MEMORANDUM

To: Zoning Board
From: Lauren A. Wasilauski, Open Space & Stewardship Director
Date: February 14, 2024
Re: BA-03-23: Kharrubi
Block 24001 Lot 37 (8 Route 518)
Bulk Variance

Figure 3: June 7, 2021 aerial image from NearMap showing a cleared lot

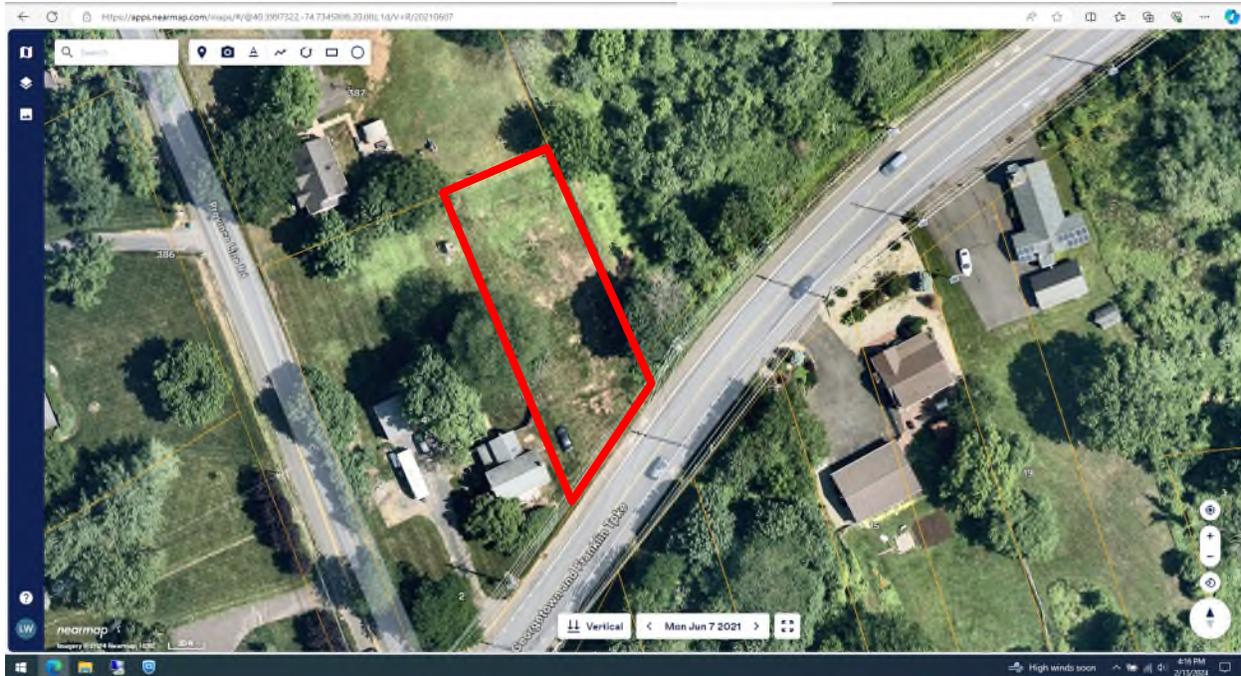
1. Tree Removal: Based upon aerial imagery obtained from NearMap, the Applicant cleared the lot of mature trees sometime between March 2021 and June 2021 – see image progression below from NearMap.

- a. The Applicant should provide testimony regarding the number and size of trees that were removed and the purpose of this clearing.
